WATERLOO METRO QUARTER BUILDING 2

**SSD-10439 - RESPONSE TO SUBMISSIONS
SUPPLEMENTARY DESIGN REPORT**

This supplementary design report has been prepared to respond to Submission received for SSD-10439.

Level 23 - Plant Room

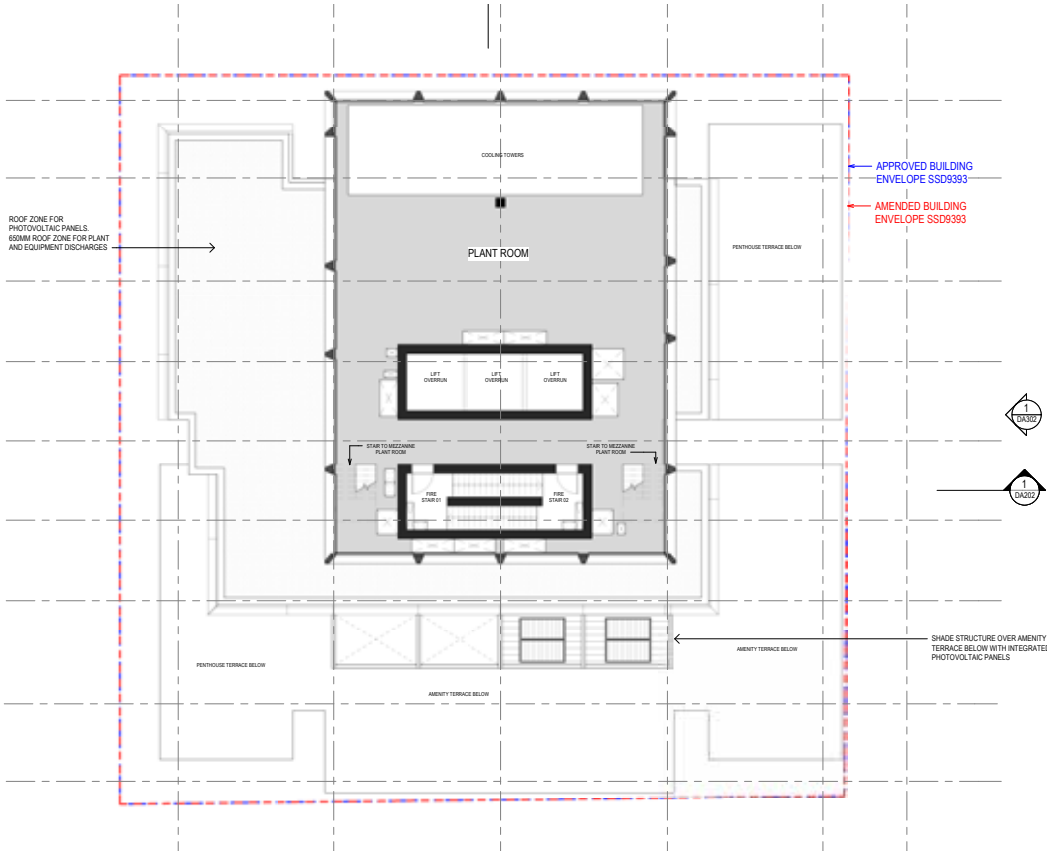
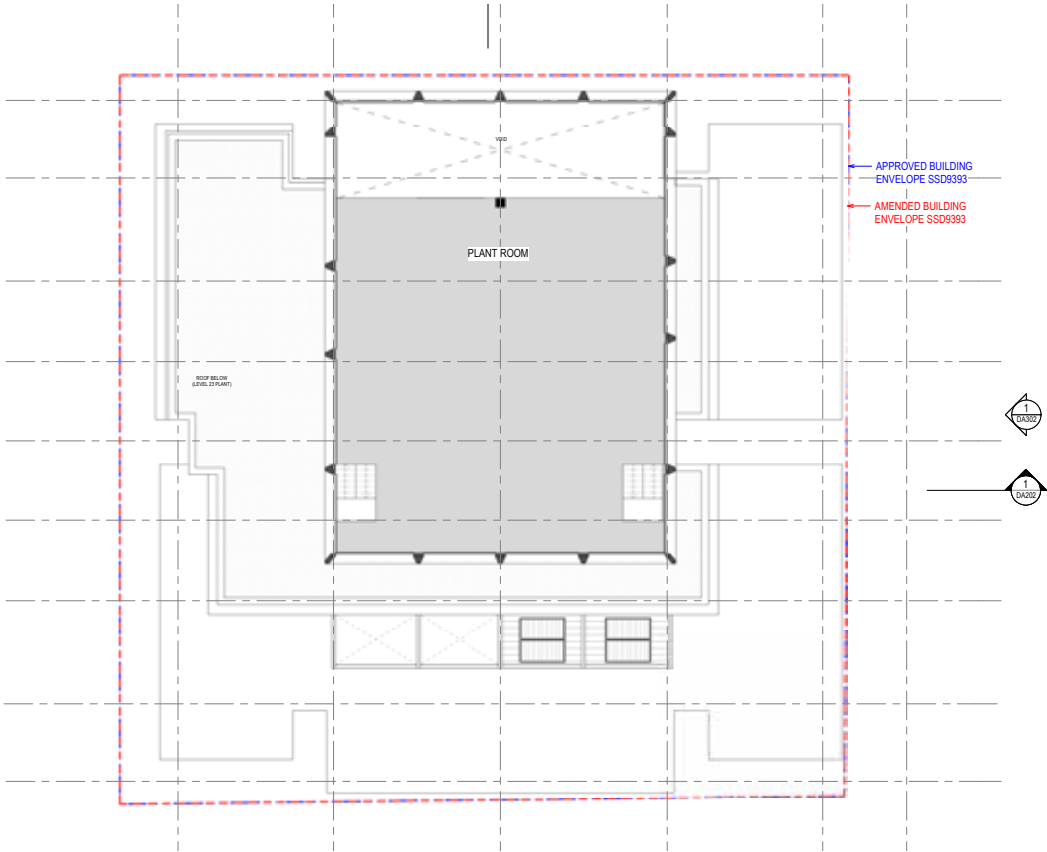
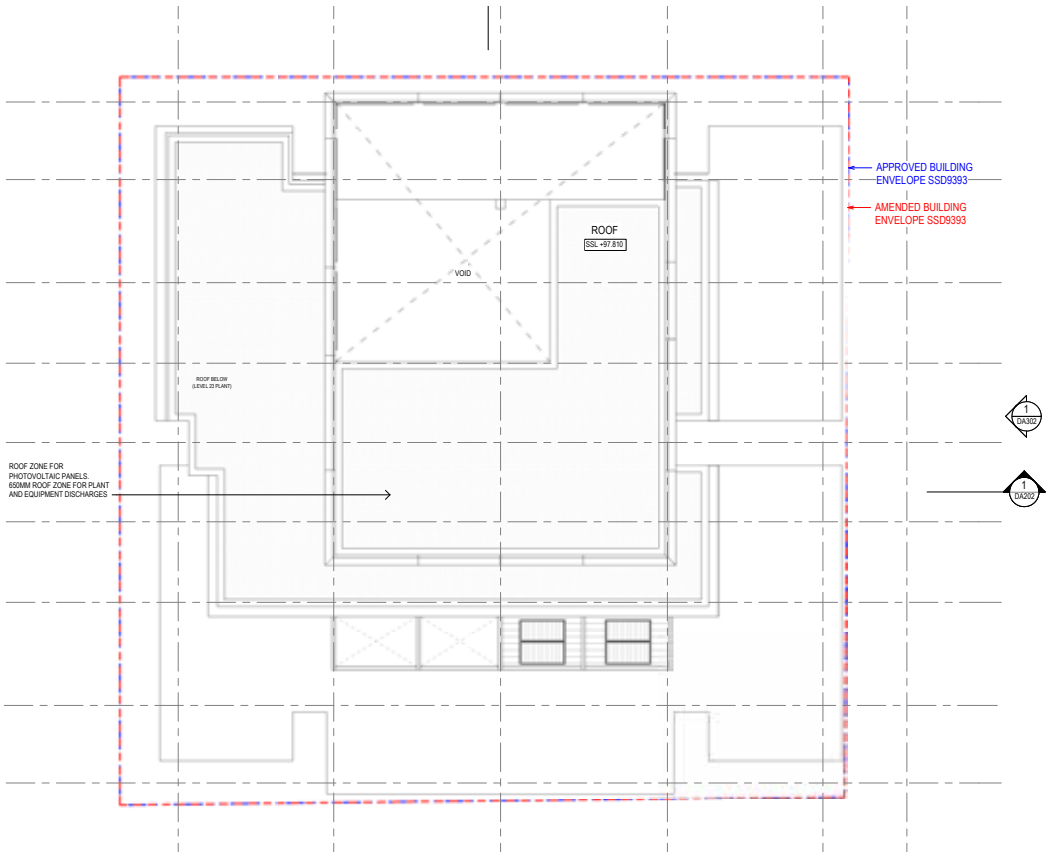
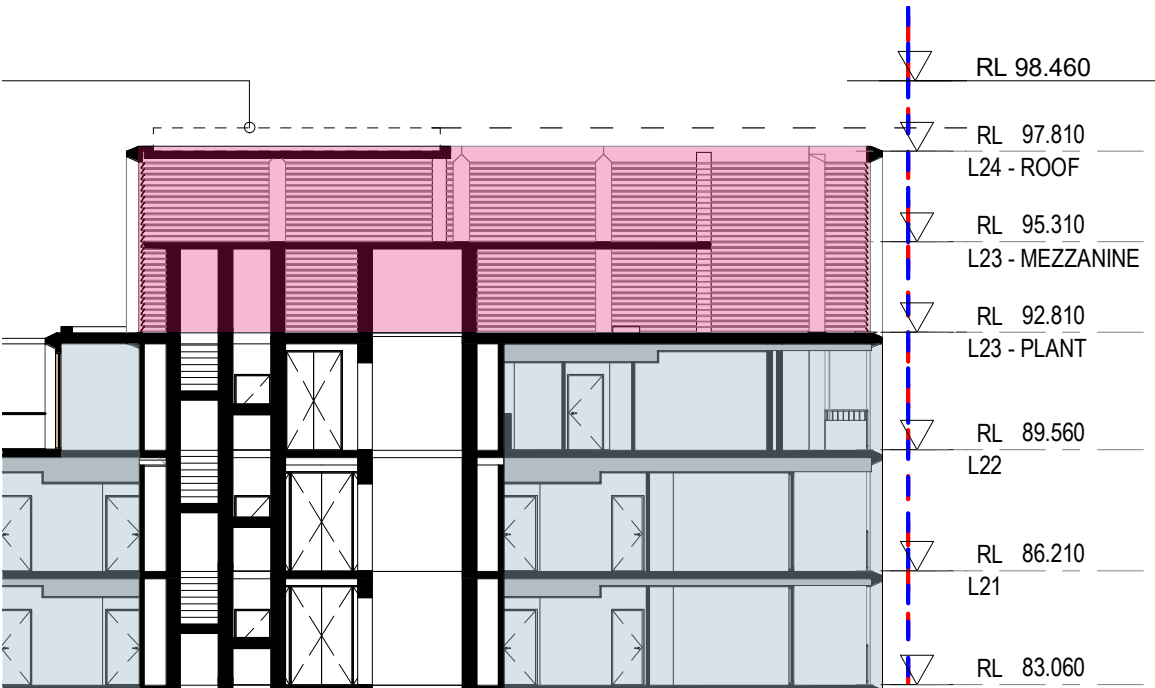
16 (g) A large consolidated plant room is provided on Level 24, which is supported as this removes the need for ad-hoc equipment on the adjoining areas of roof. A condition of consent is recommended to require the integration of all roof services within the Level 24 plant room and to prohibit the installation of any roof plant on any other areas of the roof.

_As noted in the submitted DA drawings, level 23 and level 23 mezzanine will house plant equipment servicing building 2. This will be a semi enclosed structure designed to be part of the overall building facade.

_The roof area adjacent to level 23 plant room and the roof is proposed to house photovoltaic panels to achieve ESD targets.

Apartment planning to maximise amenity.

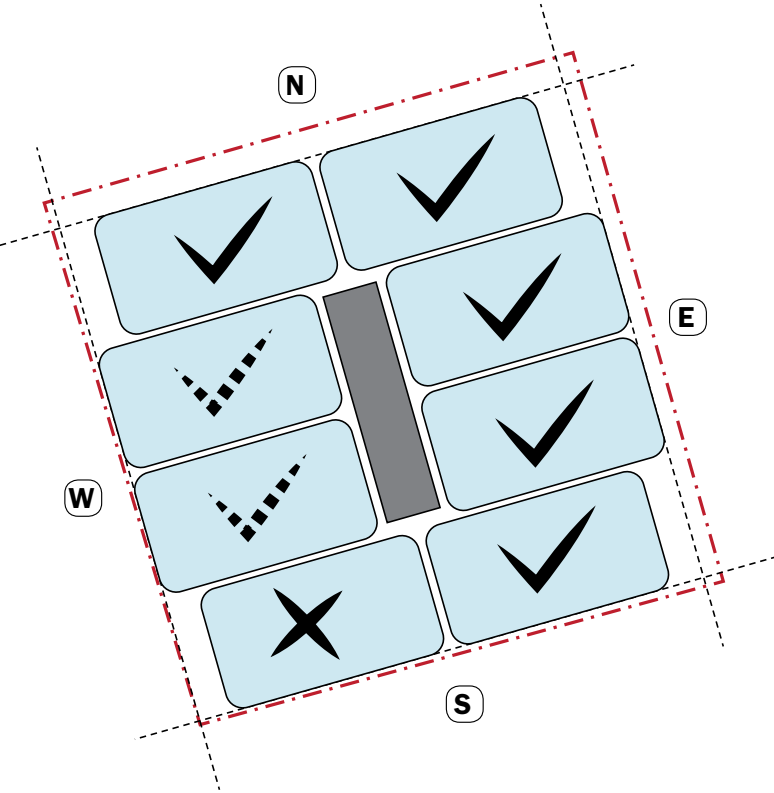
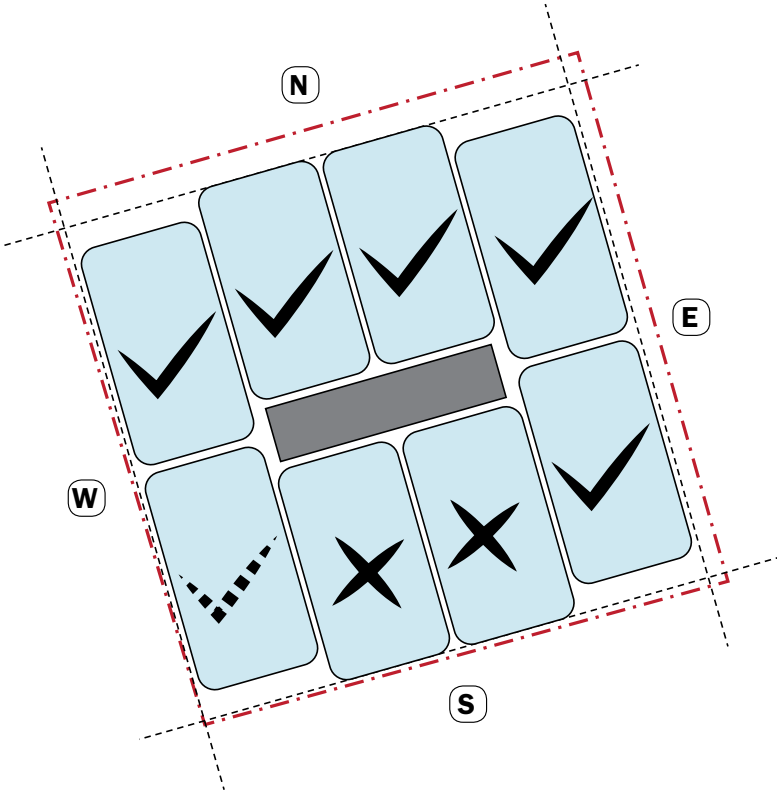
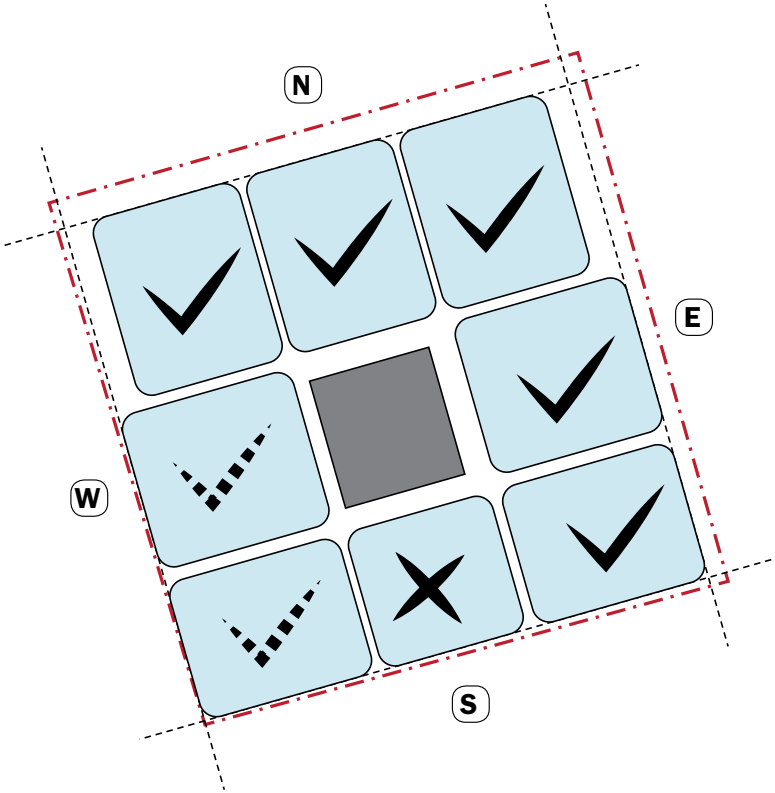
18. Solar access – Objective 4A-1 of the Apartment Design Guide (ADG) recommends, as a minimum, 70% of apartments be provided solar access to living rooms and balconies for at least two hours during midwinter. The application states that 57% of apartments achieve the design criteria. The City does not support the applicant's justification for the non-compliance by including solar access after 3pm as this is not reflected in the design guidance or criteria and is of little thermal benefit due to the low altitude of the sun.

The tally incorrectly includes apartments as complying where only the living room glazing meets the criteria, rather than both living room glazing and balcony. This is not a correct interpretation of the ADG, which requires both to achieve a minimum of 2 hours of sunlight in order to be counted in the minimum 70% of apartments. This applies to both west facing apartments, and apartments at lower levels in the northeast corner of the plan, which are shaded by the southeast corner of Building 1. These apartments have been counted where only the balcony achieves the minimum amount of sunlight (loss of 3 apartments). The stated solar access tally is incorrect and should be updated to reflect a correct interpretation of the ADG design criteria. It is likely to be well below the minimum when measured correctly.

- _Apartment planning options were explored to maximise east and north facing apartments while eliminating south facing apartments within the envelope.
- _The typical lower floor apartment layout of Stage 1 DA plan has 2 south facing apartments, whilst the 2 and 3 bedroom south apartments have south facing balconies where they won't receive any direct sunlight mid winter.
- _The proposal is an improvement from the concept approval.

West facade rotated towards north

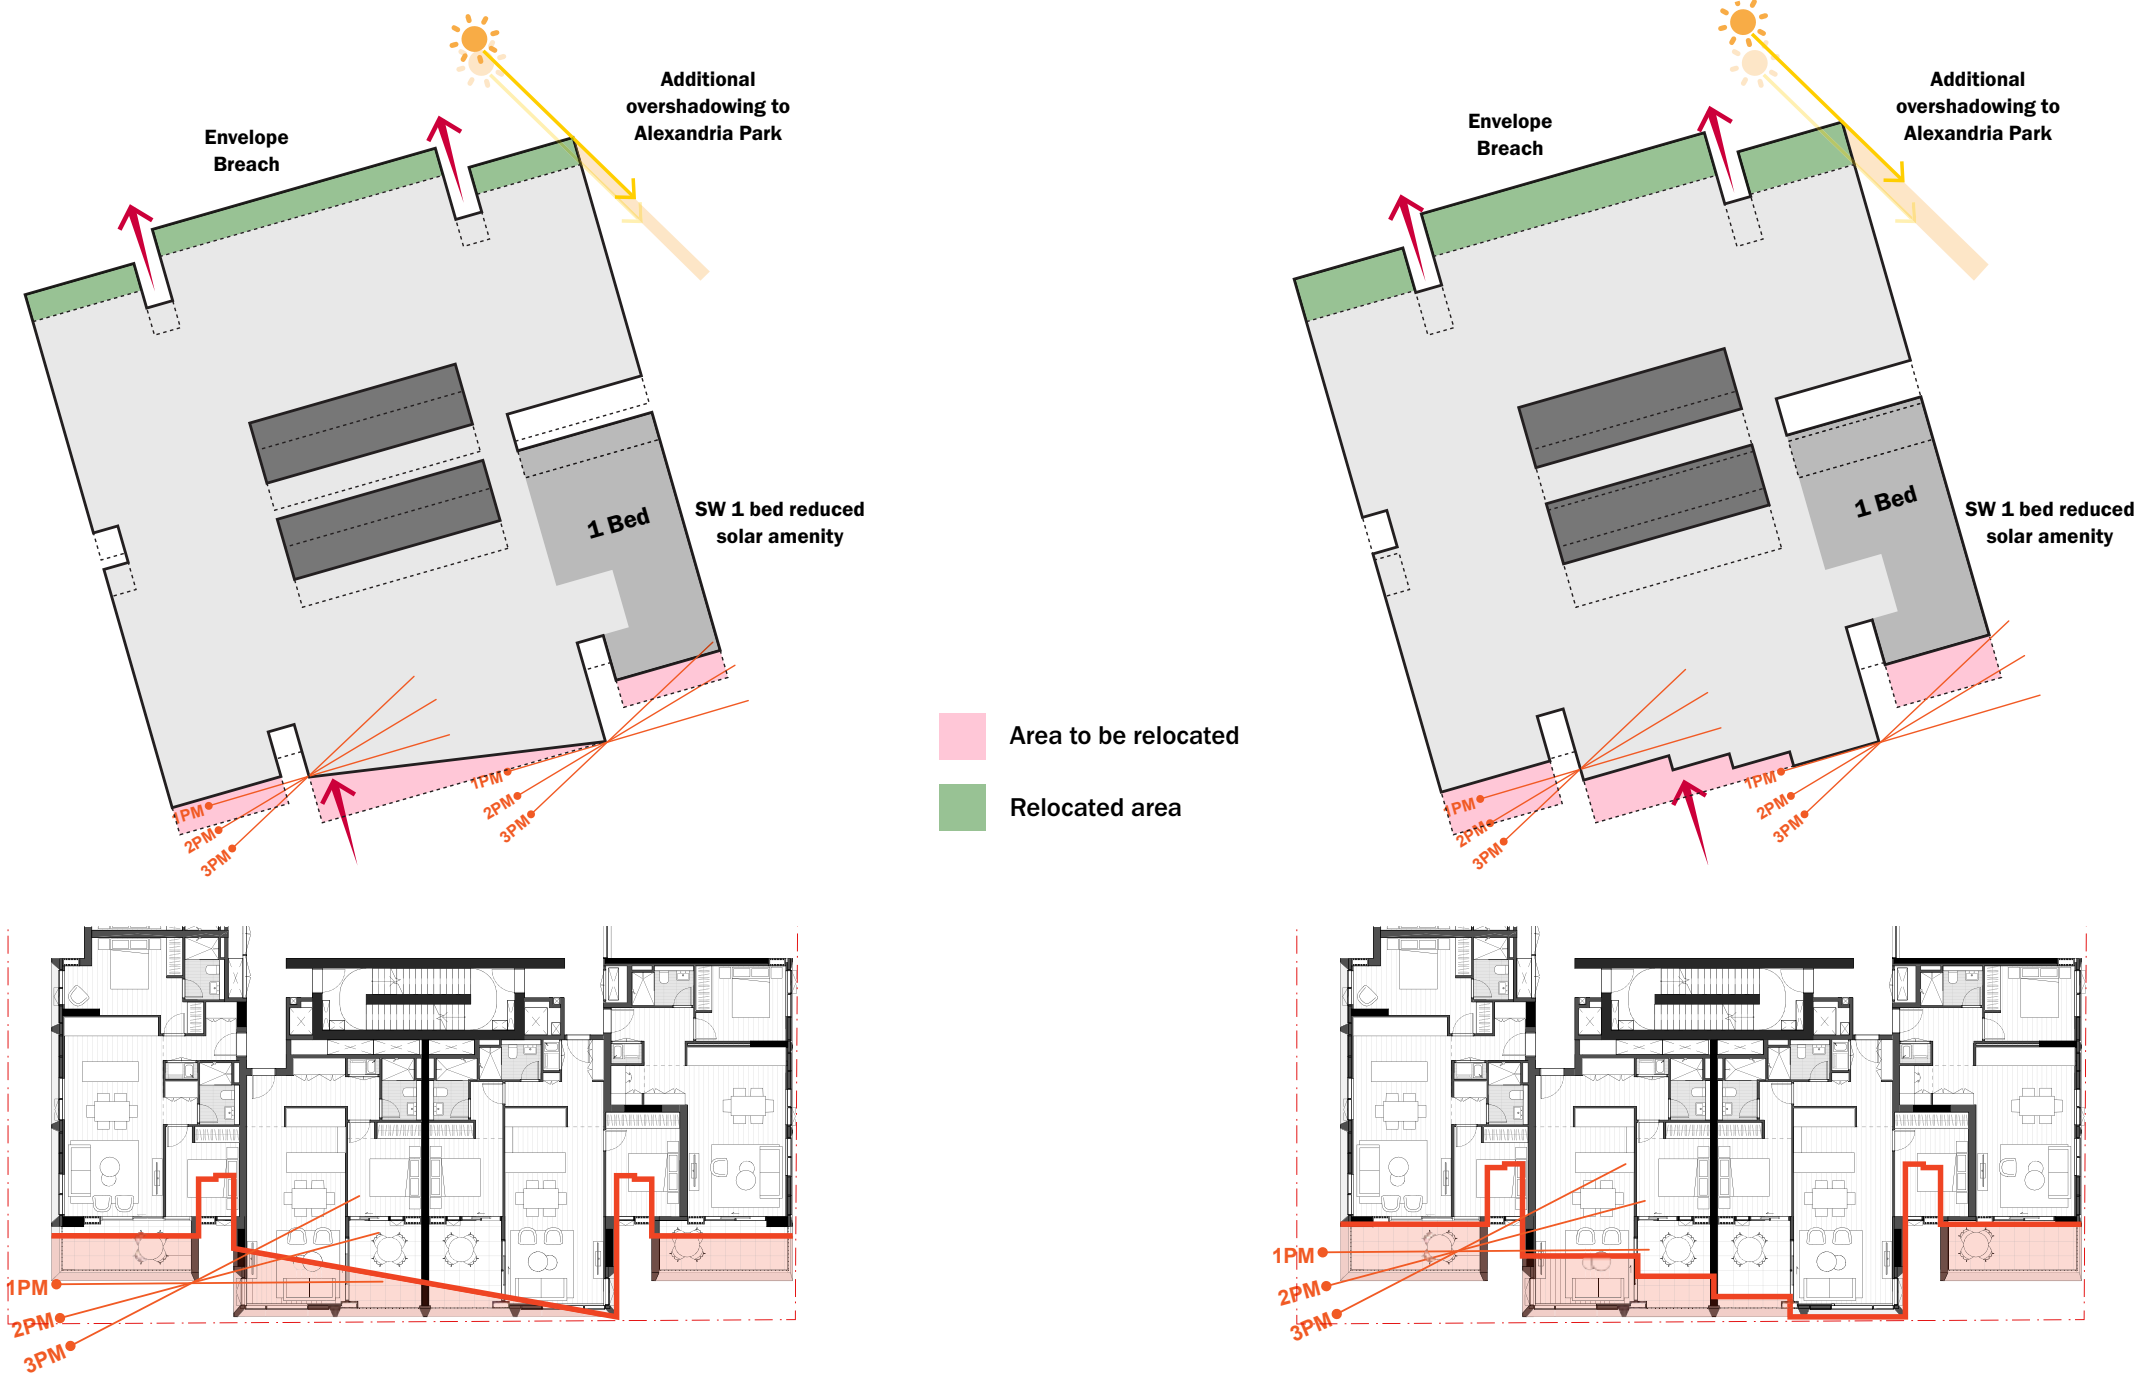
No information is provided to illustrate alternatives to achieve compliant solar access within the widely accepted criteria (9am to 3pm) such as staggering the floor plate to allow sun ingress from 1pm. Winter sunlight is generally discounted outside 9.00am-3.00pm as it is of little thermal benefit due to the low altitude of the sun. The more detailed solar information in the architectural design report demonstrates that even at 1.30pm, sunlight is too oblique to the facade and there is no benefit to extending the assessment criteria.

- _A number of designs were explored to maximise solar amenity on the optimised apartment layout.
- _The diagrams on the right seek to demonstrate the problematic nature of seeking absolute compliance with the Apartment Design Guidelines, rather than using them as a way to optimally balance the quality of user experience. The proposed design is non-compliant as proposed, by a margin of 30-minutes on the winter solstice.

- _The options to the right present a way to make the building strictly compliant with ADG solar access requirements – both approaches are detrimental to the quality of internal apartment space, the urban experience of the architecture and overshadowing to Alexandria Park. The design team has worked with the Design Review Panel to finesse the design of the building, including proportion, materiality and structural integration to ensure a balanced approach to apartment amenity, architectural expression and overshadowing to public spaces.

- _The proposed design solution does not adopt the approach shown here and was noted as still receiving reasonable solar access during winter days by the Design Review Panel.
